## ArevaEPRDCPEm Resource

**Response to  
Request for Additional Information No. 371, Supplement 21**

**QUESTIONS for Structural Engineering Branch 2 (ESBWR/ABWR Projects) (SEB2)**

**Figure 03.07.02-66-1—Solid Element Basemat**

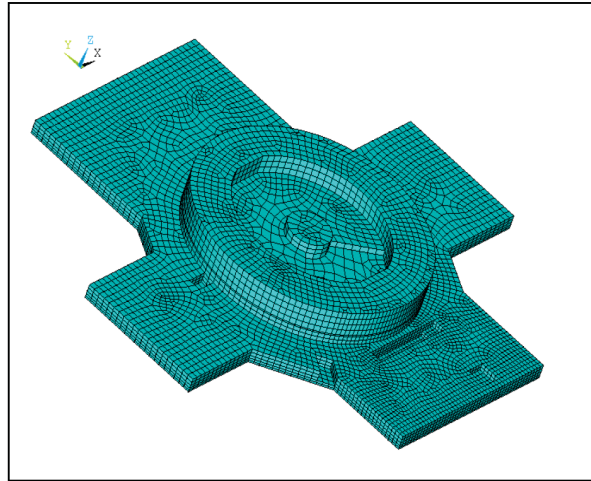
- a. When a plate element of a section of the basemat of one thickness is connected to an adjacent element of a different thickness, the centerlines of the adjacent elements are connected continuously in a single plane. However, the actual basemat is typically poured with the bottom of the basemat at one elevation. If the basemat has a varying thickness, the actual centerline does not lie in a single plane but its location changes as the thickness of the mat changes. As this has the potential to introduce non-conservative errors in the design loads for the basemat, the staff requests that the applicant evaluate the impact of the analysis simplification regarding the location of the basemat centerline on the bending evaluation of the basemat and the use of the analysis results for the design of the mat.

- b. In embedding the model into the foundation, the basemat can be located with its centerline at the elevation of the nominal bottom of the basemat in which case the length of the attached walls must be increased affecting their frequency response or the centerline can be located at its actual elevation somewhat above the foundation bottom. This latter method leaves the effective lengths of attached walls approximately correct but the seismic input to the model is at an incorrect elevation. In either case the assumptions used can lead to non-conservative structural accelerations and an under prediction of seismic loads acting on the structure. The staff requests that the applicant describe the details of the placement of the embedded model into the foundation material using these plate elements and its potential effect on the accuracy of the analysis results and the impact on the building's seismic design loads.

U.S. EPR FSAR Tier 2, Section 3.7.2.3.1.4 and Figures 3.7.2-151 and 3.7.2-152 will be added as described in the response and indicated on the enclosed markup.

Figure 3.7.2-151—Solid Element Basemat

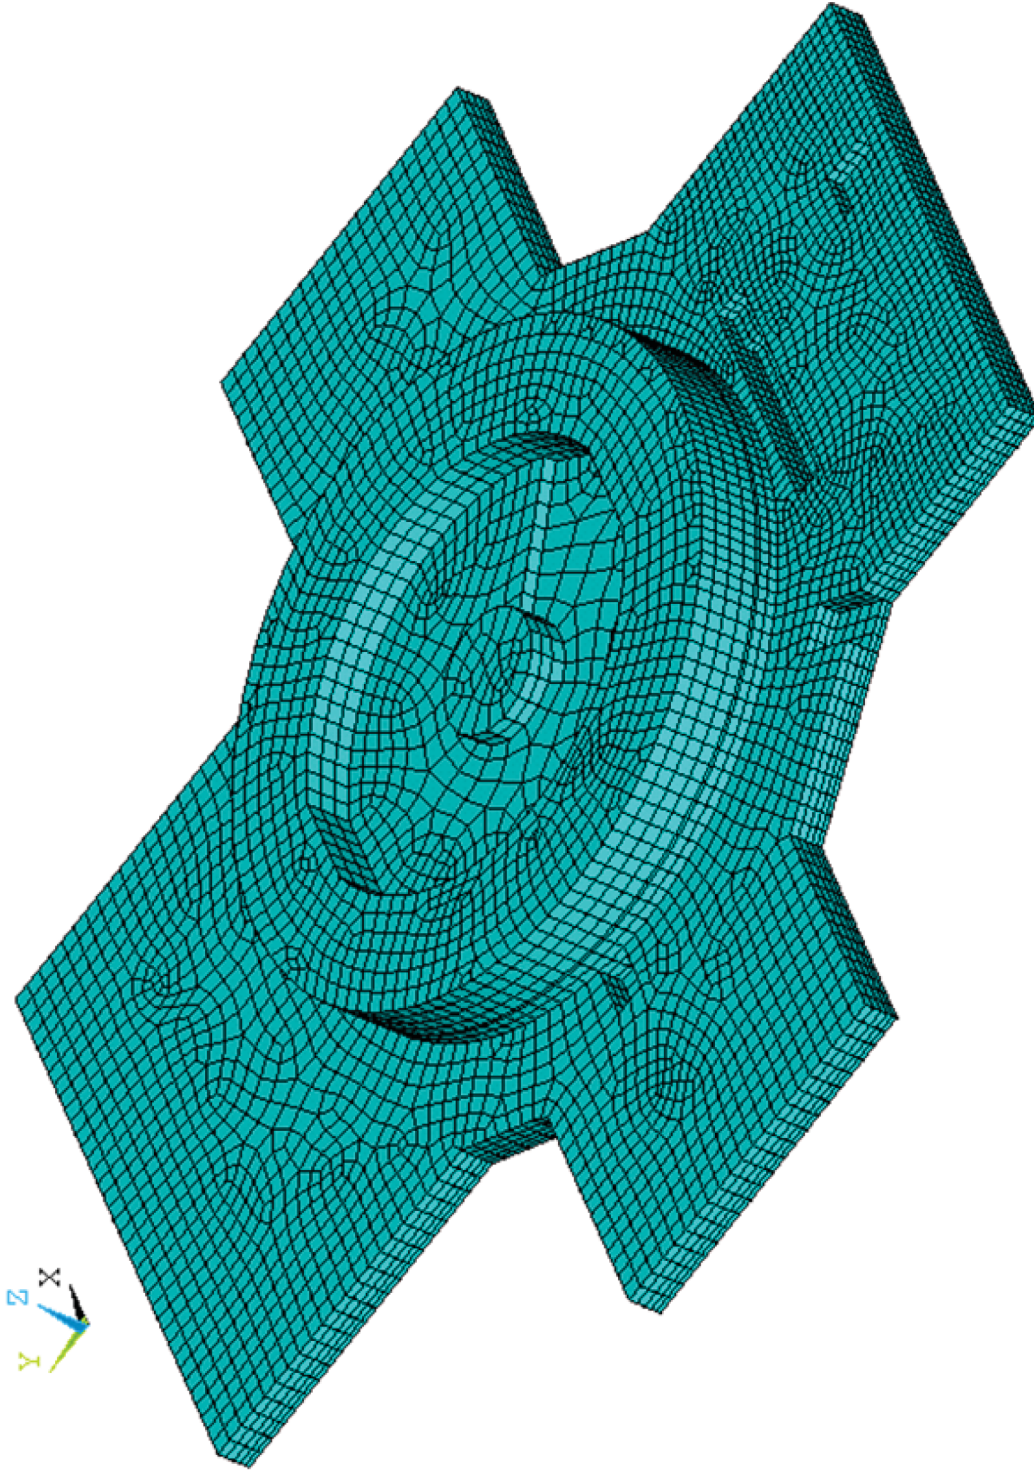
03.07.02-66

Figure 3.7.2-152—Foundation Basemat Model with Solid Element Basemat

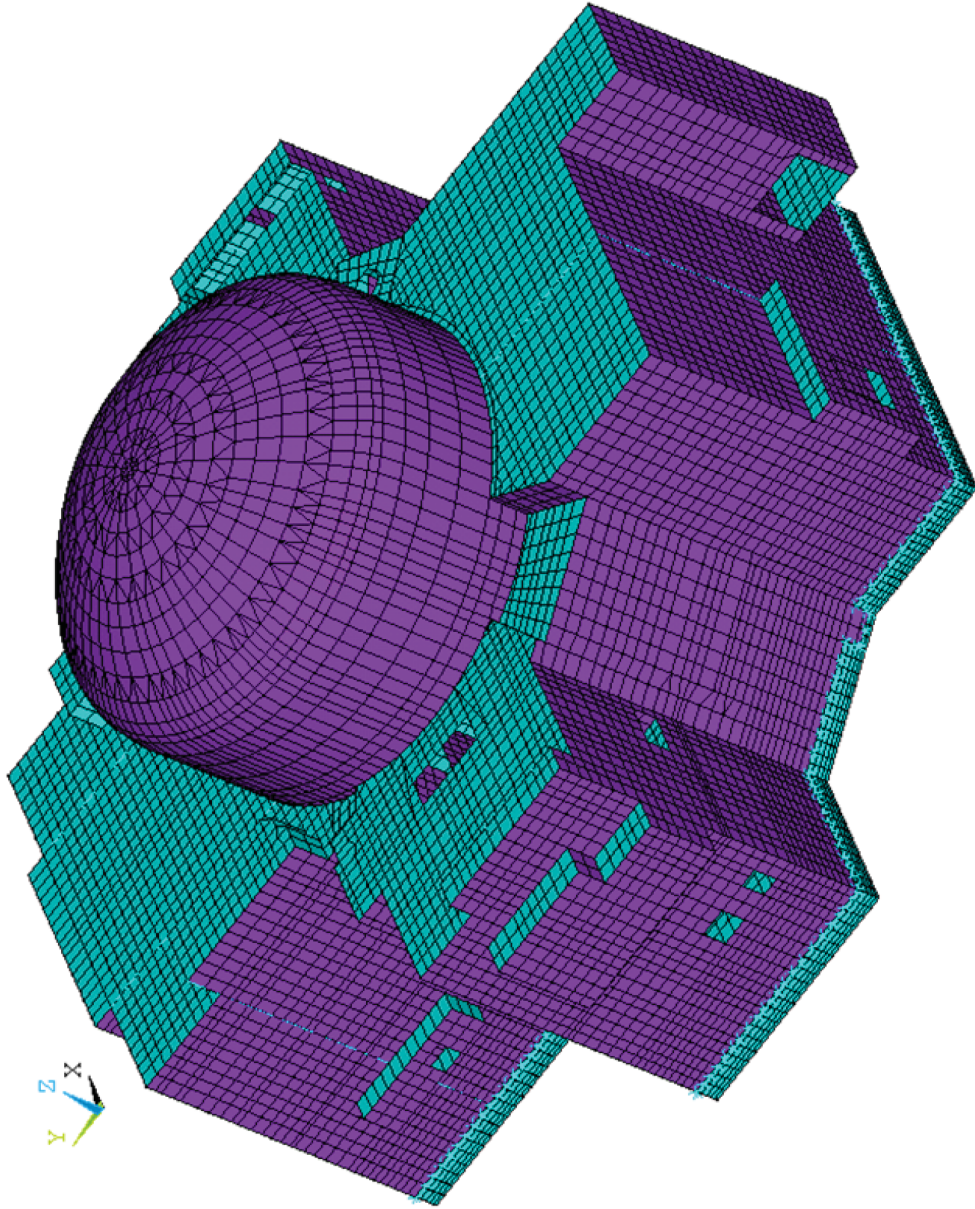
03.07.02-66
